Government of the District of Columbia

Department of Transportation

MEMORANDUM

SUBJECT: ZC Case No. 78-17A – Judiciary Plaza (450 5th Street NW)

Figure 1 | Site Plan

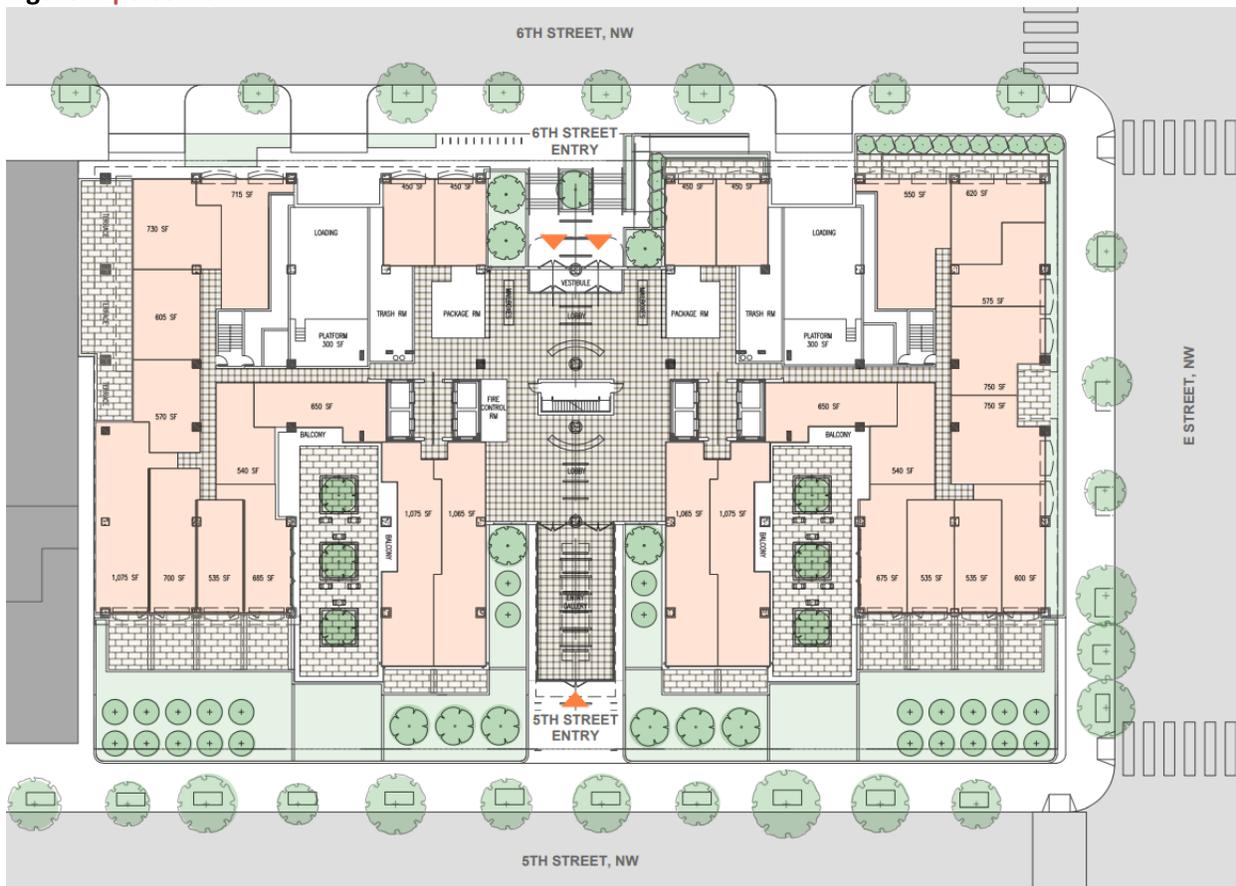
While the preliminary public space plans, shown above in Figure 1, are generally consistent with DDOT standards, there are several considerations that need to be reviewed in greater detail during the public space permitting process:

- The project should maintain or expand the landscaped area in public space surrounding the existing building, consistent with the Downtown Residential Streetscape Guidelines;
- Ensure the adjacent streetscape design meets the requirements of the Downtown Streetscape Regulations and Gallery Place-Chinatown Streetscape Design Guidelines;
- Streetscape improvements along 6th Street should attempt to narrow the existing curb cuts where possible, especially the two loading areas, where Autoturn diagrams show there is ample space for truck movements;
- All building entrances must be at grade with the sidewalk so that no stairs or ramps will be necessary in public space;

- Submit a detailed curbside management plan with proposed signage for review and approval by DDOT Curbside Management Division (CMD). If CMD requires multi-space meters for the remainder of the frontage, they will be at the Applicant’s expense;
- Provide a plan showing the detailed design of the long-term bike storage room so PSD can confirm it meets the requirements in Title 11 of DCMR, Subtitle C § 800, Title 18 of DCMR, § 1214, and DDOT *Bike Parking Guide* best practices, including larger cargo/tandem spaces;
- Determine final locations for the inverted-U bicycle racks; and
- Any future outdoor café patios will require a public space occupancy permit.

Figure 4 | Existing and Proposed Curbside Designations

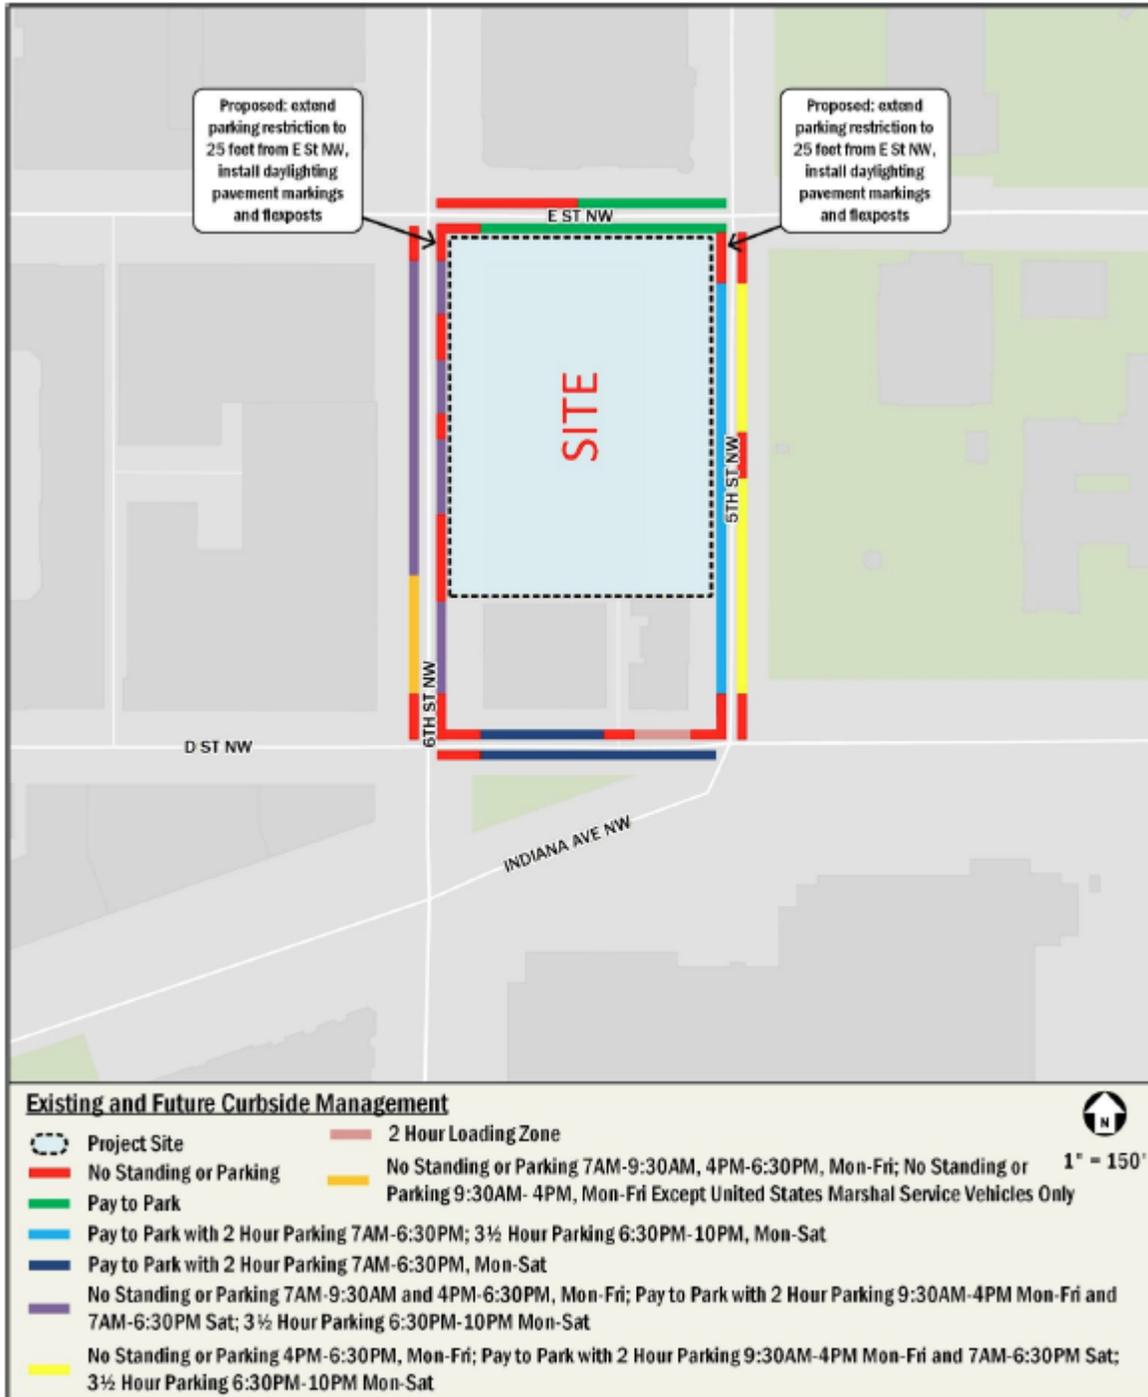
The site currently has metered parking along 5th, 6th, and E Street frontages, with varying time of day restrictions, which the Applicant is proposing to maintain, as shown below in Figure 4. DDOT is generally supportive of this concept, however, a detailed curbside and signage plan must be submitted during public space permitting for review and approval by DDOT's Curbside Management Division (CMD). At that time, the plan may be refined by CMD and the exact signage placards will be determined. If multi-space meters are required by CMD then they will be at the Applicant's expense.
